CITY OF LEWISTON
PLANNING BOARD MEETING
Monday, September 10, 2012 – 5:30 P.M.
City Council Chambers – First Floor
Lewiston City Building
27 Pine Street, Lewiston

TO: Planning Board
FROM: David Hediger, City Planner
DATE: September 6, 2012
RE: September 10, 2012 Planning Board Agenda Item IV(a)

Site Plan Re-Submission
Review Comments and Responses
Cumberland Farms, 753 - 793 Sabattus Street, Lewiston, ME

SITE PLAN
 OF:
CUMBERLAND FARMS
 753-793 SABATTUS STREET
 LEWISTON, MAINE
 FOR:
CUMBERLAND FARMS, INC.
 100 CROSSING BOULEVARD
 FRAMINGHAM, MA 01702

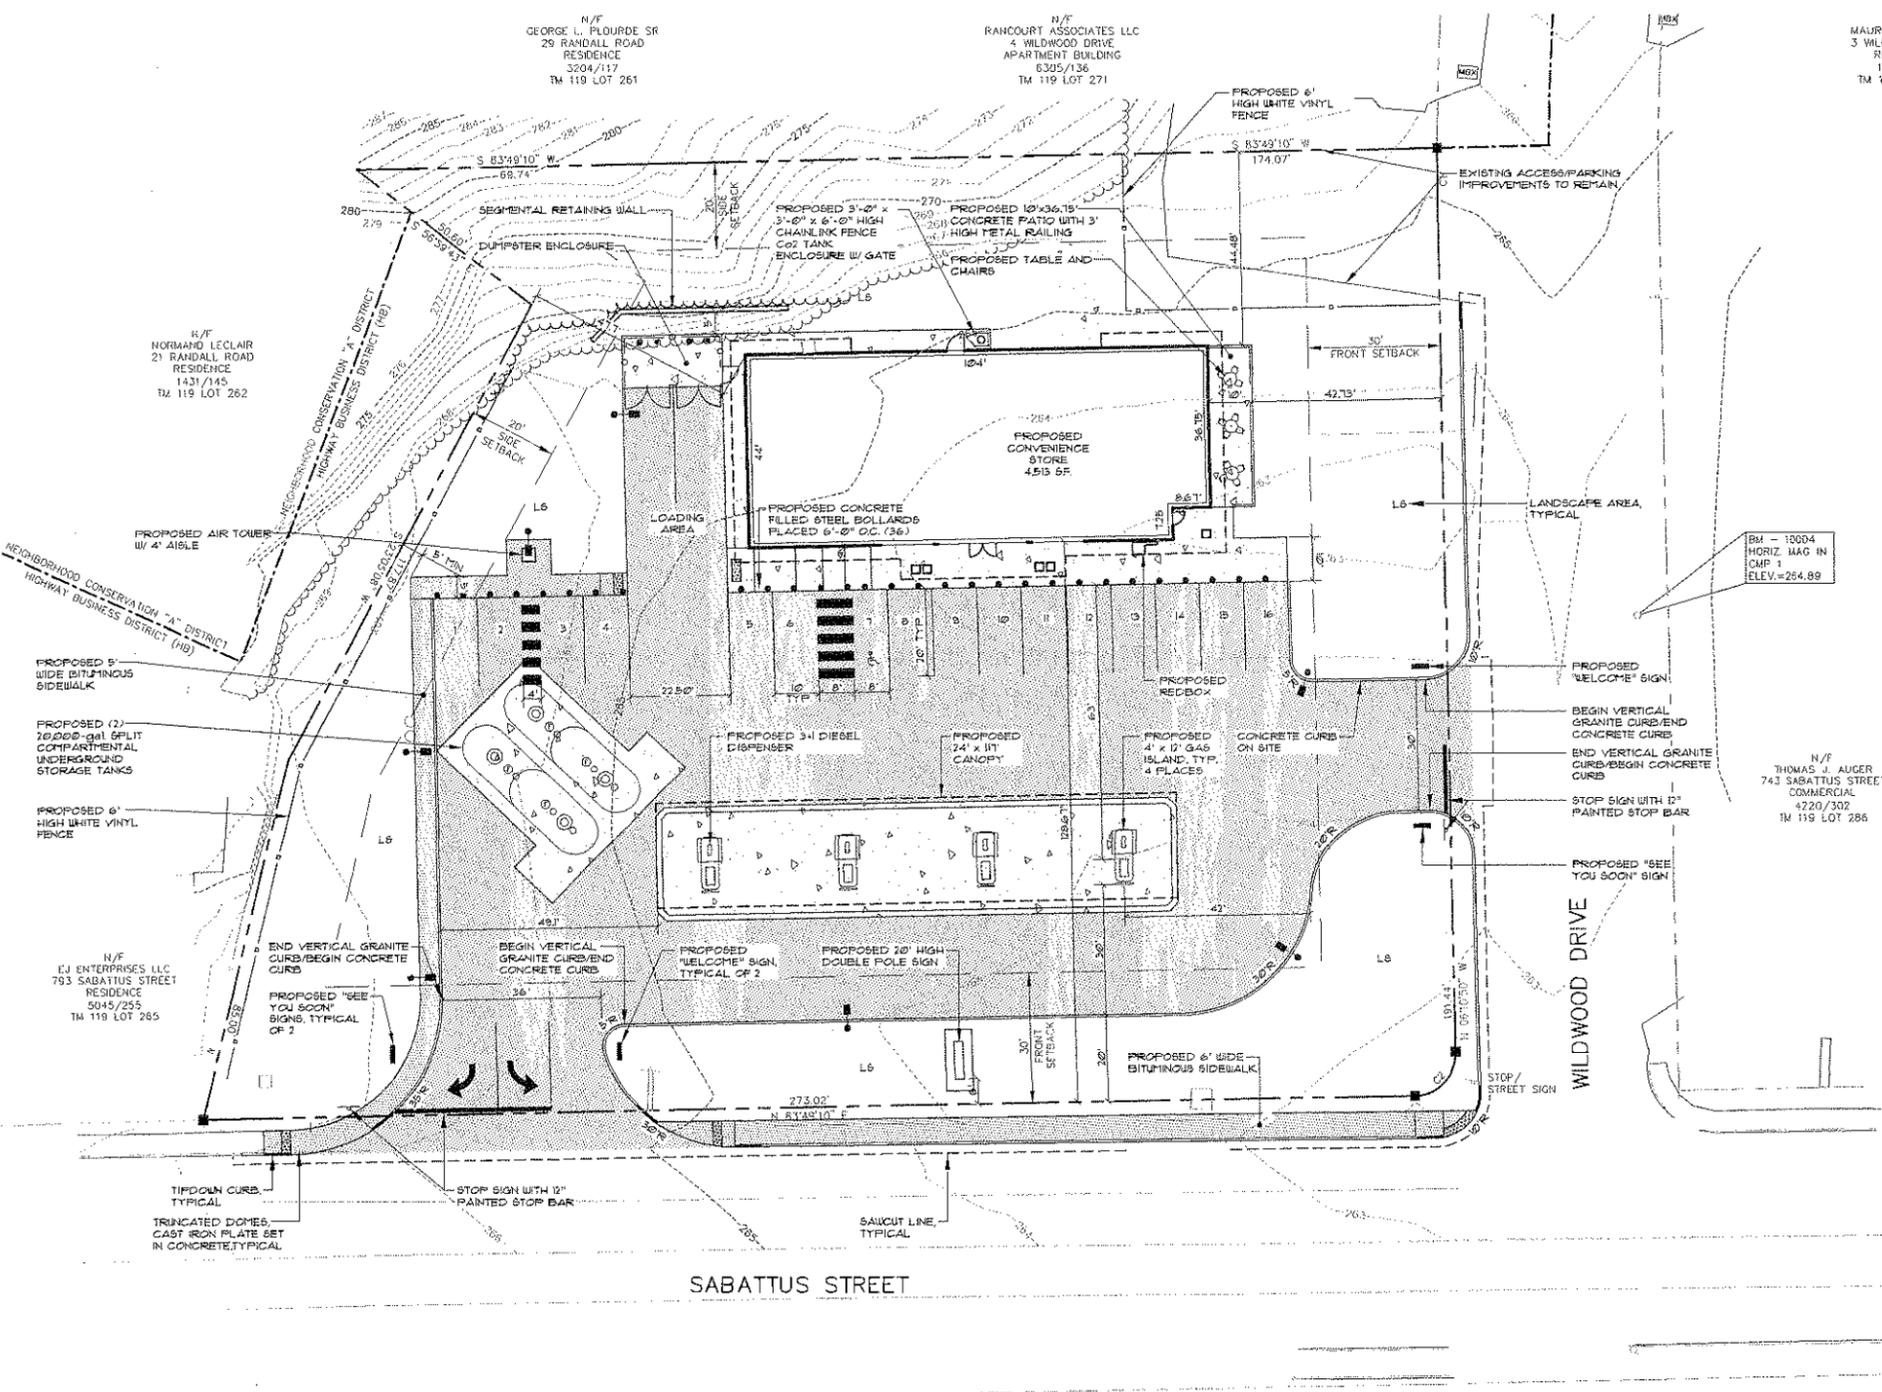
1. *Sheet 3: plan should call out existing paved area abutting the property at 4 Wildwood Drive. Also note and/or detail should be provided for proposed stockade fence.*

2. *Sheet 3: pavement is proposed within 5' of westerly property line. The Highway Business district requires a 10' yard unless a modification is requested referencing the specifics of Article IX, Sections 9 and 10. Zoning analysis table should reflect district yard requirements.*

3. *Sheet 3: please demonstrate proposed sign location meets applicable criteria of MRSA Title 23, §1914, Section 4. Waiver from MDOT is an option. Sign may be relocated to larger green space on corner of Wildwood and Sabattus to meet statute. Verify sign location will not create a sight distance issue.*

4. *Sheet 3: light poles-detail and/or note should be provided for pole height (recommended not to exceed 25' high) with cut off fixtures.*

5. *Sheet 3: Verify driveway entrance signs will not exceed 4 square feet per side.*

- 2. Sheet 3 - The truncated domes within the City Right of Way shall be cast iron plates placed in concrete.*

We have been in contact with Robert St. Clair of the Maine Department of Transportation relative to the waiver. We have made a request of the Planner Director for the required letter from the City on the waiver request. We anticipate submitting for this waiver prior to the Planning Board meeting of September 10.

The light poles locations are only shown for reference on the Site Plan. The poles are called out on the Lighting Plan as 14' poles with 2' bases.

Included with this submission is a plan that details the driveway entrance sigs and confirms that the size does not exceed 4 square feet (s.f.).

The callout on the Site Plan has been revised to indicate that the truncated cones will be an iron plate cast in concrete.

GRADING AND UTILITY PLAN
 OF:
CUMBERLAND FARMS
 752/793 SABATTUS STREET
 LEWISTON, MAINE
 FOR:
CUMBERLAND FARMS, INC.
 100 CROSSING BOULEVARD
 FRAMMINGHAM, MA 01702

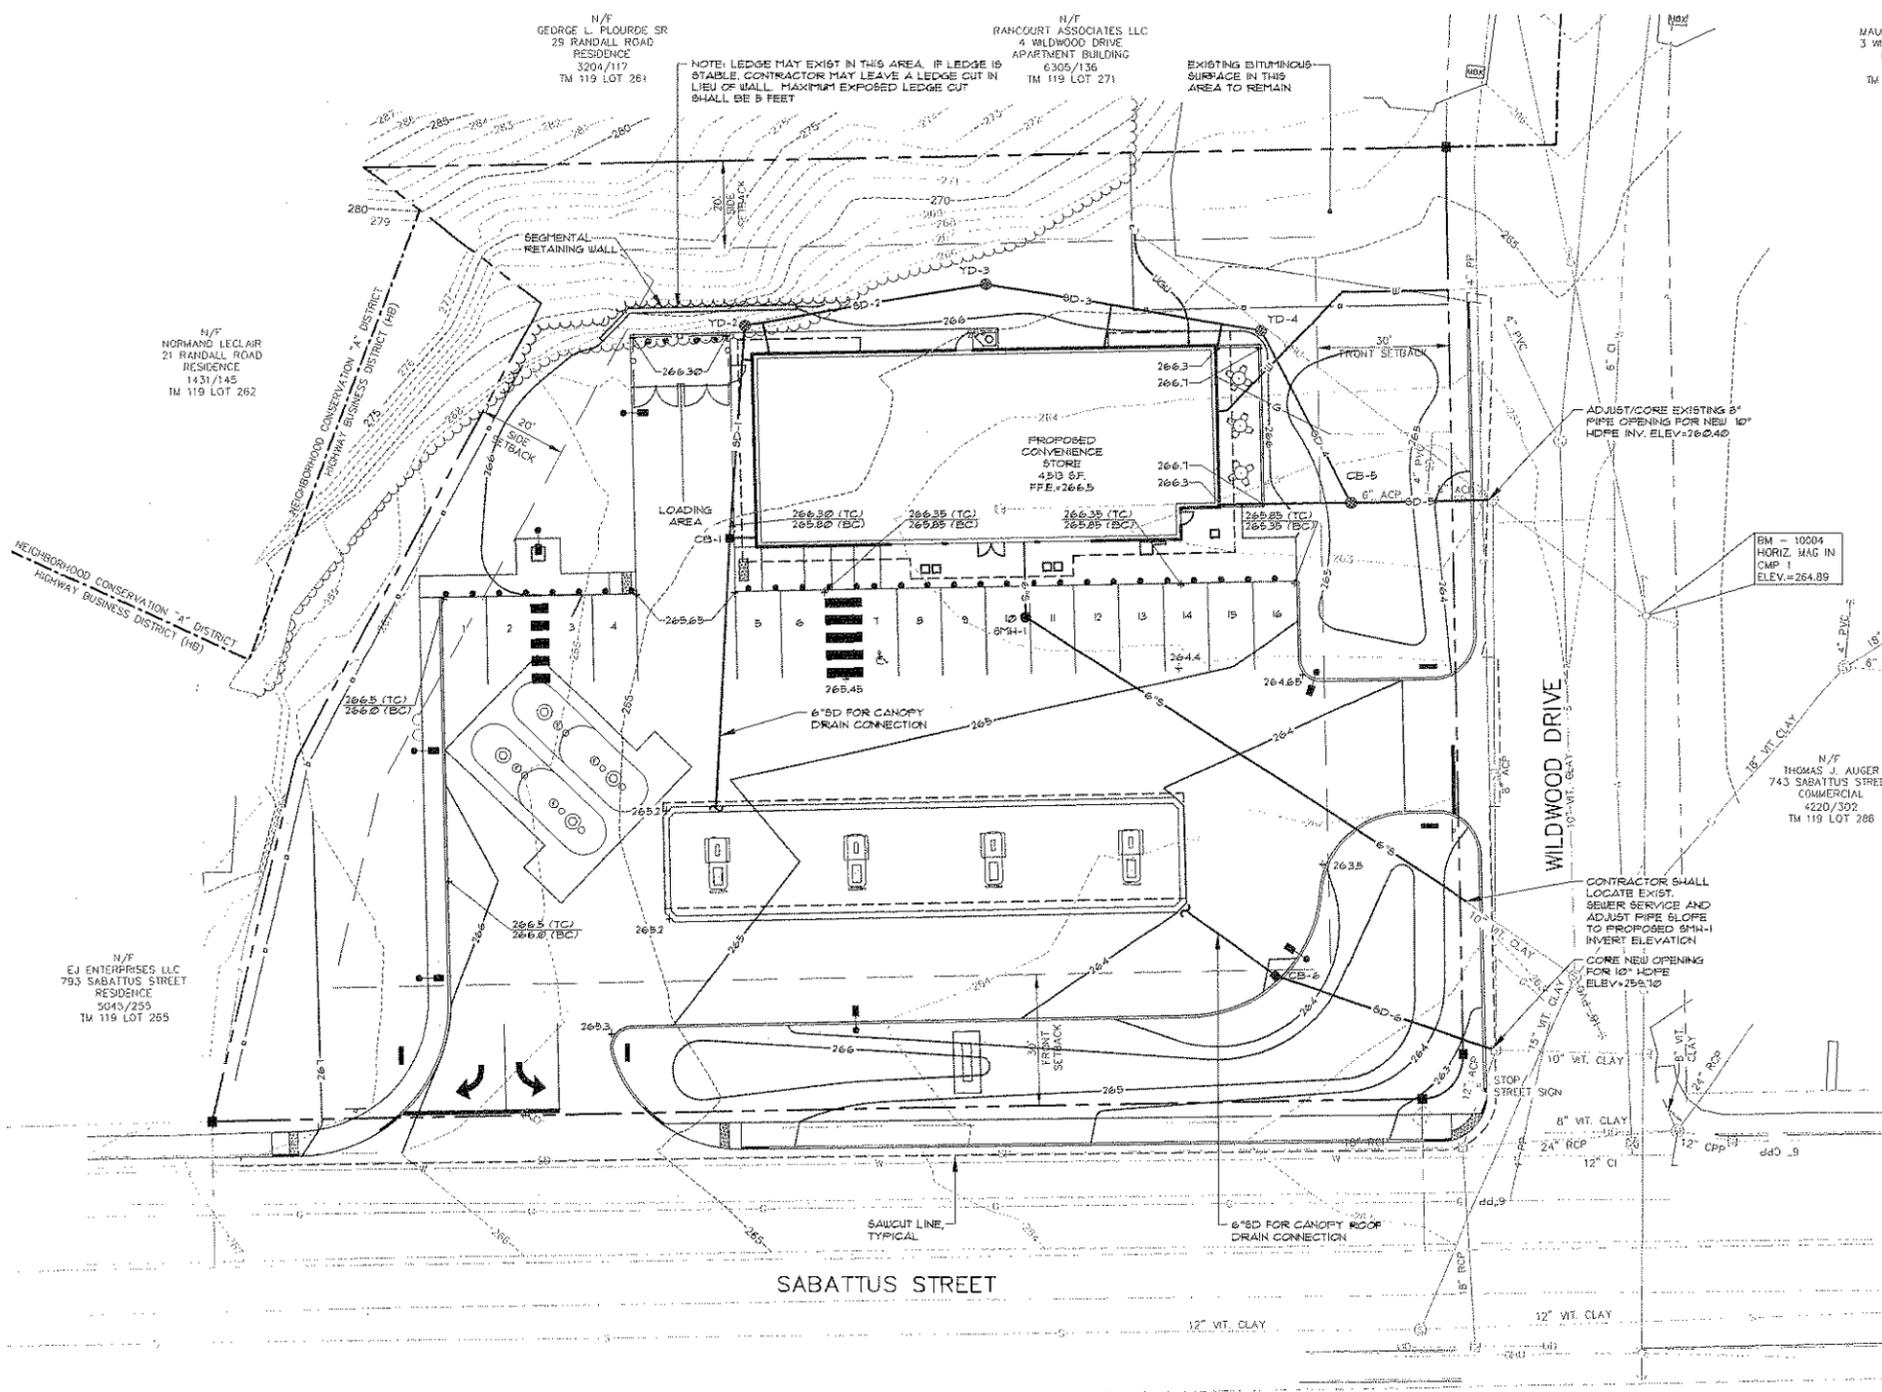
- 4. Sheet 5 - Yard Drain 5 shall be revised to be a 4' Catchbasin with a 2' sump to collect silt prior to entering the City system.*

- 6. Sheet 5 - The proposed 10" stormdrain from the site is entering an existing 8" AC pipe (see comment 1), the applicant shall demonstrate that the existing 8" AC Pipe and 12" AC pipe on Wildwood Boulevard have adequate capacity to handle the flow from the site and roadway. If the pipes do not have adequate capacity they shall be upsized by the applicant.*

Calculations are enclosed that demonstrates that less runoff from the site will be going to the catch basin at the end of the 8" ACP pipe than from the current site configuration. The discharge pipe to this catch basin has been reduced to 8" to force for ponding in the depression on the project during higher intensities. The calculations also show that additional runoff goes into the catch basin on Wildwood Drive adjacent to corner as result of the diversion of the existing direct discharge from the site to the curb line of Sabattus Street being captured by the on-site system. Because of the short length of the 12" ACP, the calculations indicate an insignificant head condition from the entire contributing area.

VERTICAL GRANITE CURB
NOT TO SCALE

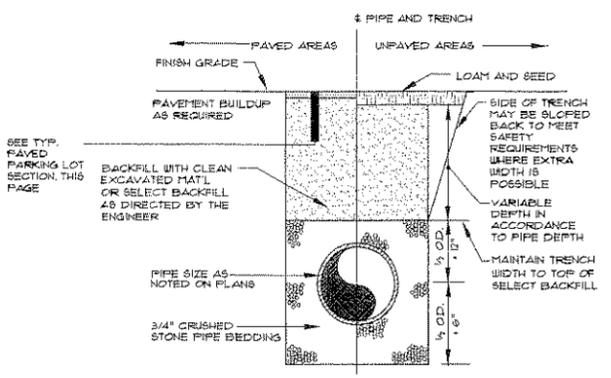
8. *Sheet 11 - The vertical Granite Curb detail shall be revised to include concrete backfill within the City Right of Way.*

The Vertical Granite Curb detail has been revised to reflect the use of concrete backfill.

TYPICAL TIPDOWN CURB INSTALLATION
NOT TO SCALE

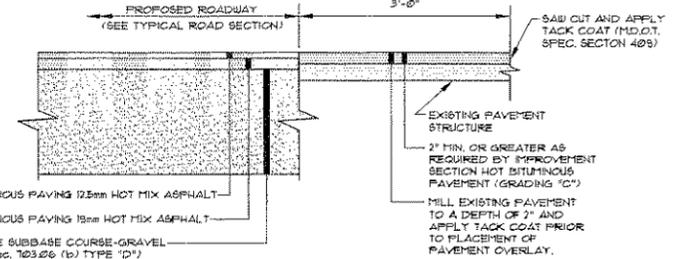
10. *Sheet 11 - The Typical Tipdown Curb Installation detail shall be revised to show 7' tipdowns in the City Right of Way.*

The Typical Tipdown Curb installation detail has been revised to reflect 7' tipdowns.

BITUMINOUS SIDEWALK
NOT TO SCALE

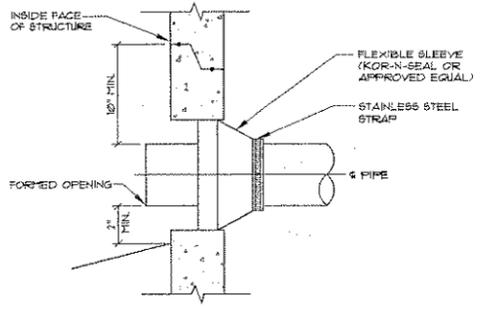
12. *Sheet 11 - The Bituminous Sidewalk detail shall be revised to reference HMA 9.5mm rather than Grade C mix as specified.*

The Bituminous Sidewalk detail has been changed to indicate a 9.5 HMA in lieu of the Grade C pavement.
